Safety Recall 70F – Toyota Camry All Weather Floor Mat Accessory Replacement for 2007 and Early 2008 Model Year Vehicles

- - Updated Information - -

Toyota Camry All Weather Floor Mat Involved in this recall

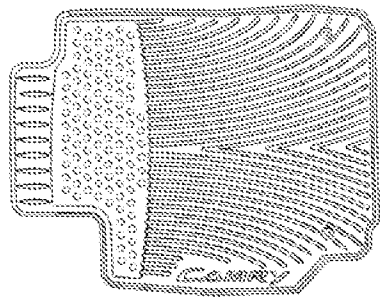
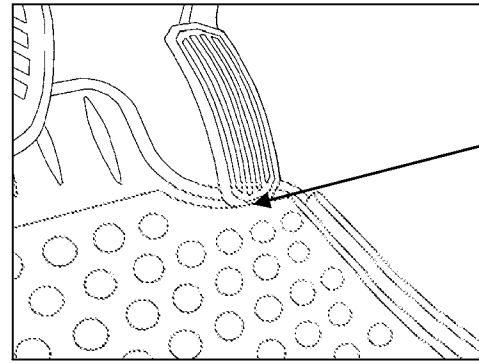
If the Toyota Camry All Weather Floor Mat is not **secured by the retaining hooks (clips)** and the mat moves forward, it may interfere with the accelerator pedal.

- The optional Toyota Camry All Weather Floor Mat is specifically engineered and manufactured for Camry vehicles. This includes two grommet holes in the All Weather Floor Mat and retaining hooks (clips) to secure the mat to the vehicle's carpet. Toyota has received reports that if the optional Toyota Camry All Weather Floor Mat (either by itself or if it is placed on top of an existing carpeted floor mat) is not secured by the retaining hooks (clips), the mat can move forward and interfere with the accelerator pedal returning to the idle position. If this condition occurs, in the worst case, it may increase the possibility of a crash.

- A newly designed replacement driver's seating position All Weather Floor Mat will be available on November 19, 2007.
- A second owner notification will be sent informing the owner that the replacement All Weather Floor Mat is now available. The original driver's seating position All Weather Floor Mat will be exchanged for the new one.
- Mailing Schedule
  - Region November 16, 2007
  - Dealer November 19, 2007
  - Owner November 28, 2007
